## Additional Criteria #2

Subject: Residential Roof Height Evaluation, Reconstructed Single Family Residence, 10230 111th Avenue N.E., Kirkland, WA 98033

Parcel No.: 206300-0020

Image #1

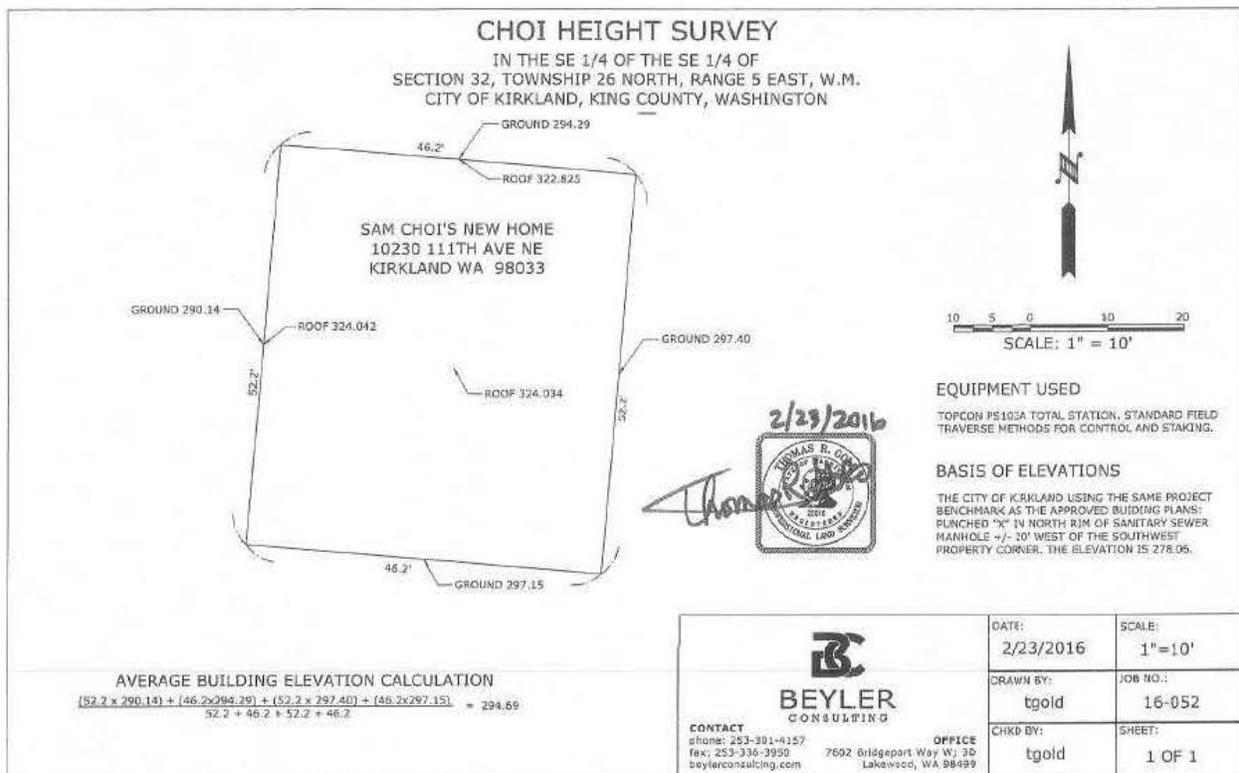
In the 3<sup>rd</sup> elevation survey (which was conducted adhering to City of Kirkland's strict direction), we are able to observe that the garage level slab has an elevation of 290.14ft. Please refer to image #1.

What's important and critical is that the existing foundation was never altered and the existing foundation was re-used in order to build the new structure. Therefore it must be safe to assume that the elevation of the garage slab of the OLD and the NEW structures are identical at 290.14ft.

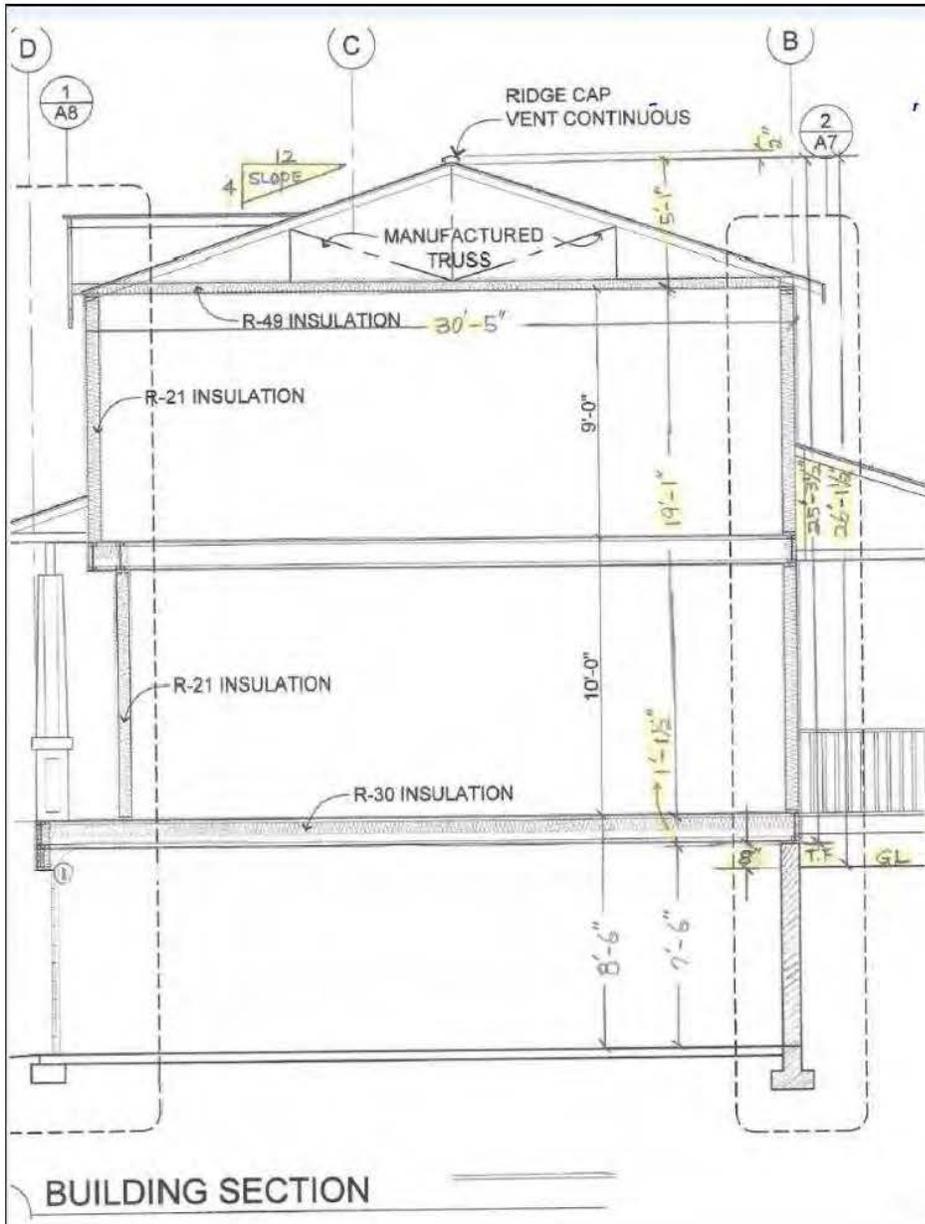
Now, Let's take a look at image #2 (shown below)

We have physically measured and the plan verifies that the garage level to the ceiling of the basement

has a height of 7' 6".

We can examine that top of foundation (or TF) is equivalent to the ceiling level of the basement.

From TF to the top of the roof is 25' 3.5" (please see the details of the addition in image #2).

Therefore if we add 25' 3.5" + 7' 6" = 32' and 9.5" or 32.79 feet.

From this calculation, we can confidently state that the total height of the NEW building from garage level to the top of the roof is measured to be 32.79 feet high.

Since we know that the garage level is 290.14 ft and the height of the building is 32.79 ft, it implies that the peak height of the NEW structure is *likely* measured at 322.93 ft. This is *likely* 3.24ft higher than the max allowed height of 319.69ft. In the variance application the peak height was measured as 324 ft therefore we have an interesting discrepancy of 324 ft vs 322.93 ft which yields difference of 1.07 ft.

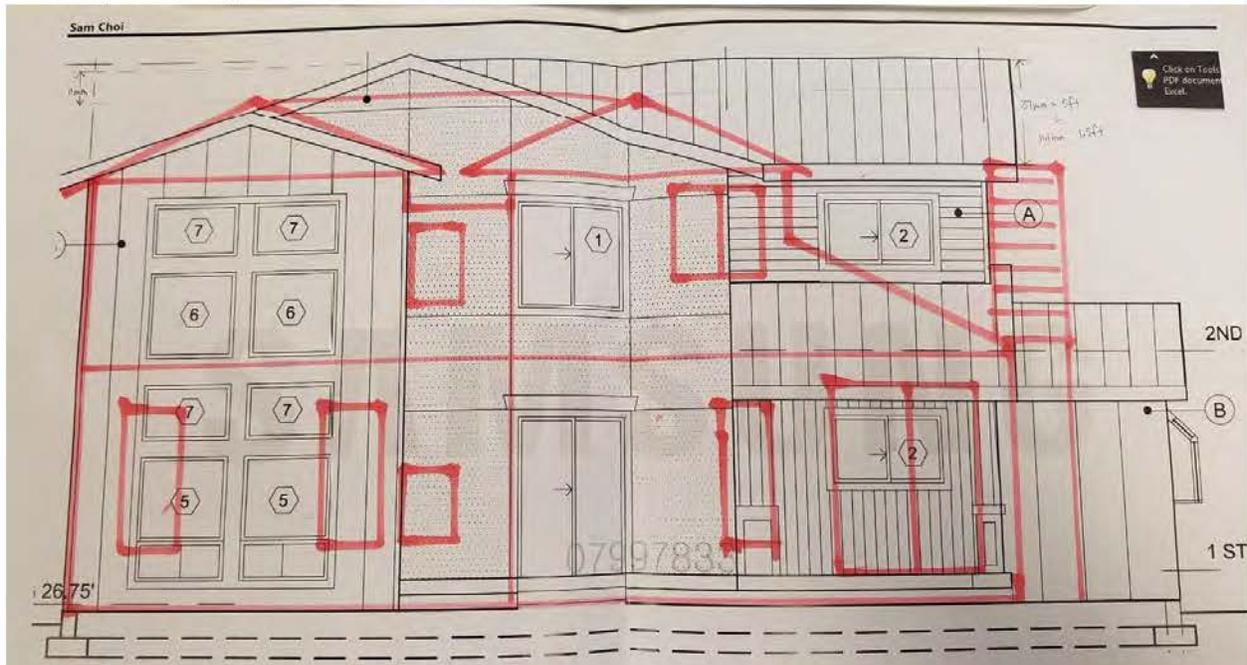
Now, let's compare the ABE of OLD and NEW

OLD: 318.76ft

NEW: 319.69 ft

The difference yields 0.93ft which means that the NEW house is allowed to be *likely* 0.93ft higher than the OLD house due to extension of the foundation towards east (or backyard). However since the OLD house was also proved to be *likely* 2.68ft higher than allowed, we will disregard this finding for time being.

FRONT VIEW FROM STREET LOOKING EAST

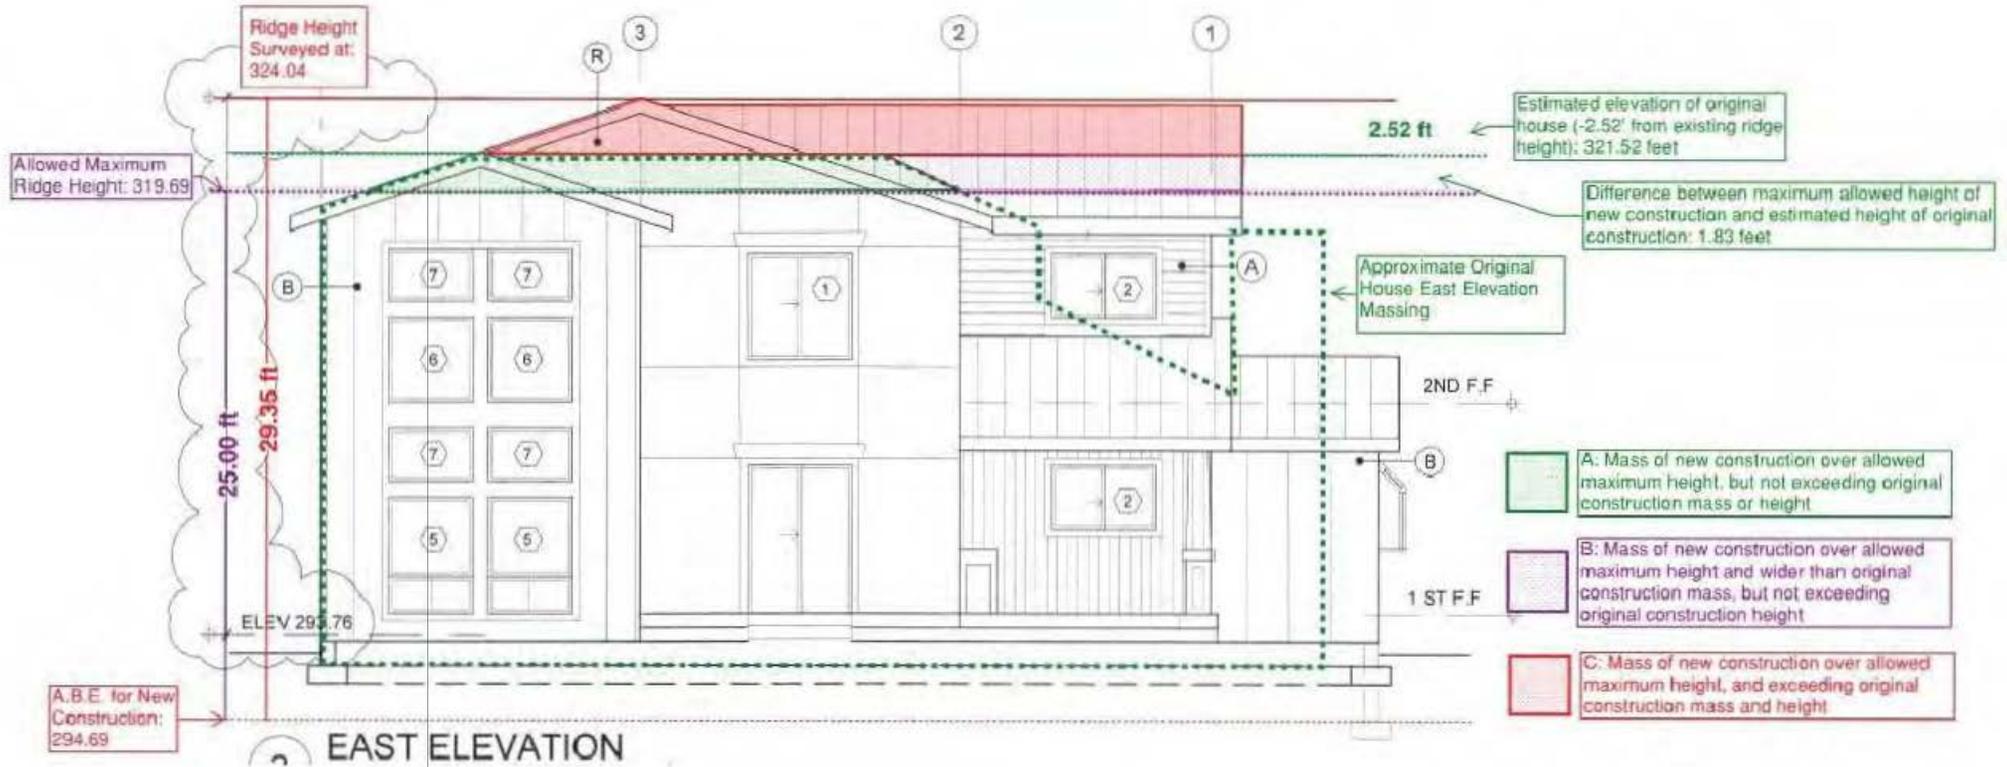
RE-USE OF ORIGINAL DRIVEWAY ELEVATION/PAVEMENT
